NUCLEAR REGULATORY COMMISSION

Title: Advisory Committee on Reactor Safeguards
 Digital Instrumentation and Control Systems
 Subcommittee

Date: Thursday, August 20, 2009

18 MS. HERRMANN: We are here to present the
19 NRC comments on the EPRI reports. EPRI requested that
20 we review both the CCF and the DAS reports. All four
21 offices participated in this review, NRR, NRO,
22 Research, and NMSS. Multiple divisions participated
23 in the review. In NRO, we had DSRA, DCIP, and NDE.
24 So, it was a concerted effort and we appreciate the
25 opportunity provide comments to EPRI.

Chronological Distribution of
Software Failures: EPRI Data

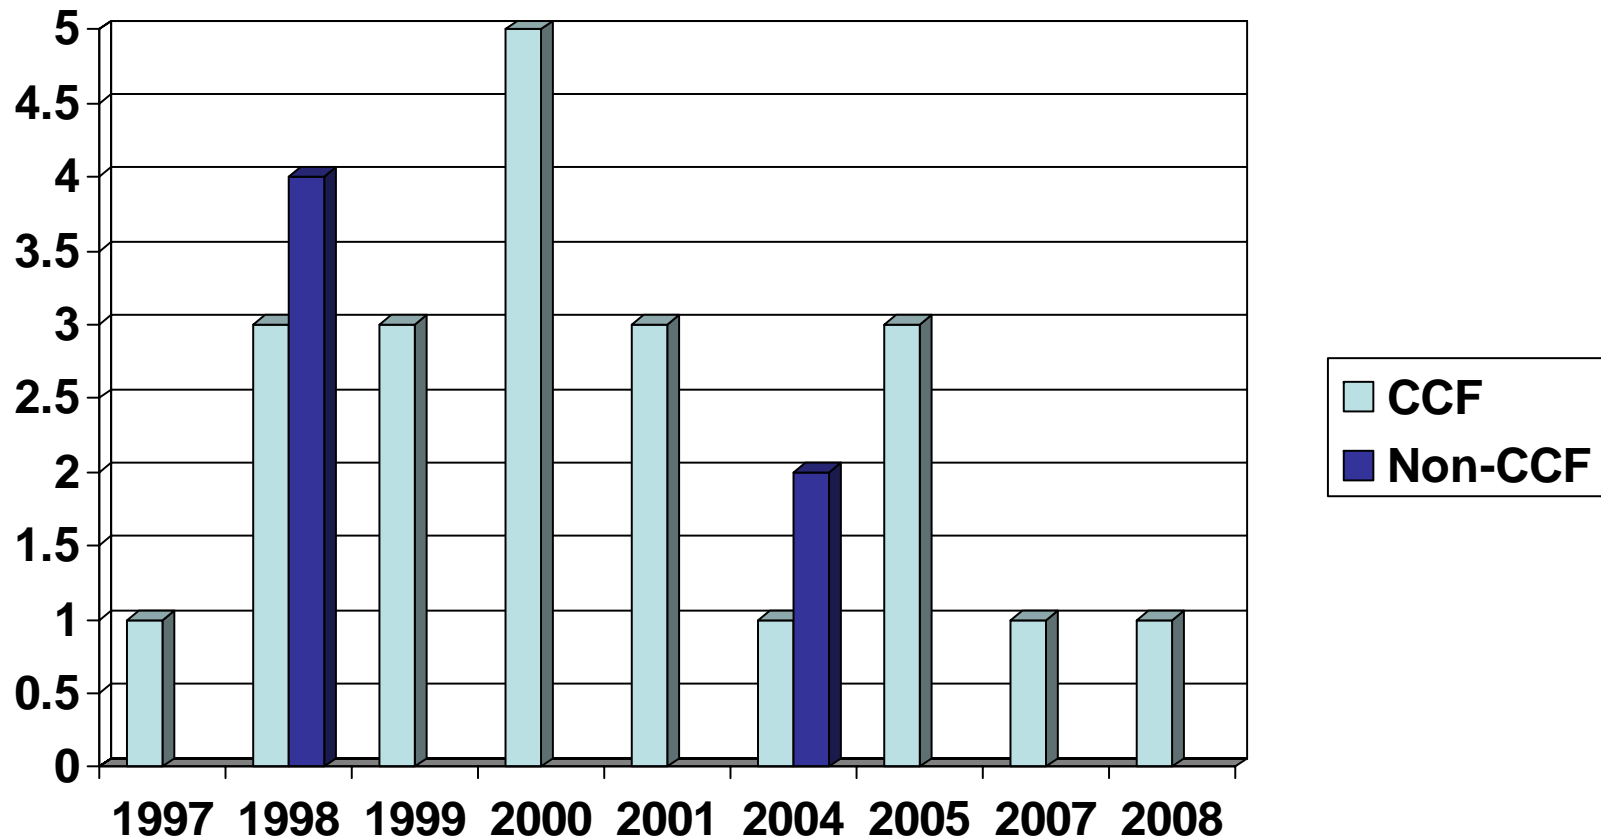
Specific Comments on CCF OE Report
